14-0574 Revision to item 10 – Otay Ranch Village 2 Parks Agreement

Please be advised that on the dais in front of you is a revised version of the attachment 2, the executed agreement. - Sheet 3 and exhibit A-2.

# Exhibit A-2

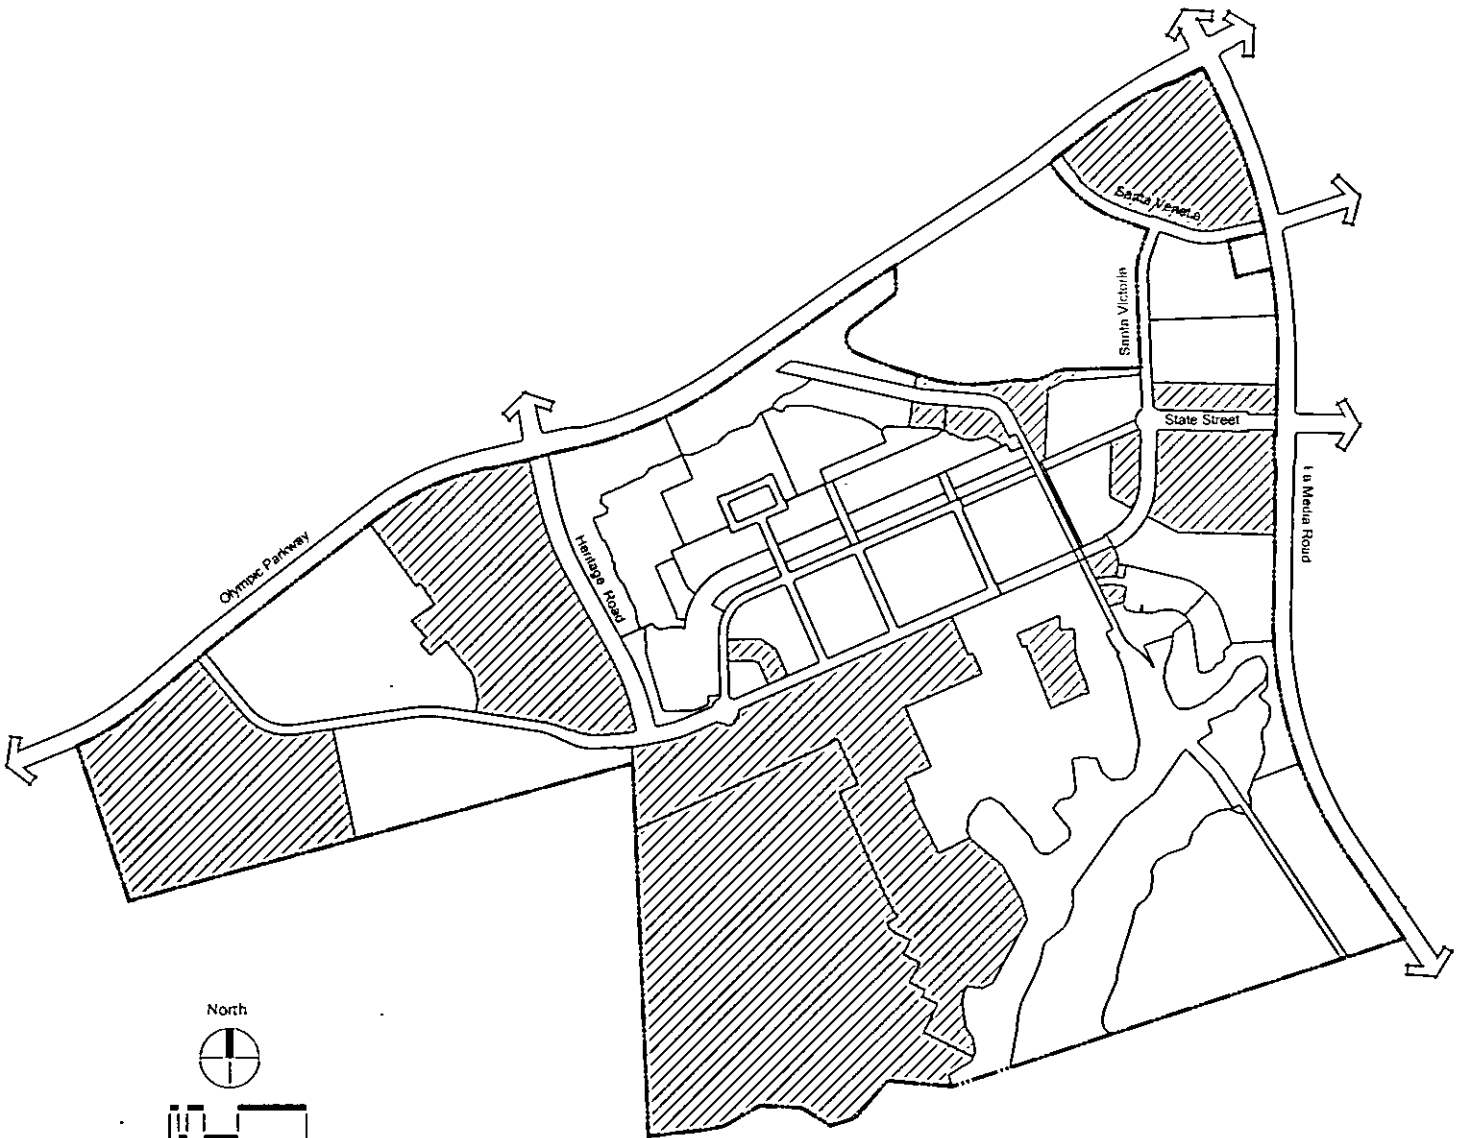
Also Exhibit A-2 was not attached to the agreement. Slip sheets with these two changes will be inserted into the executed agreement.
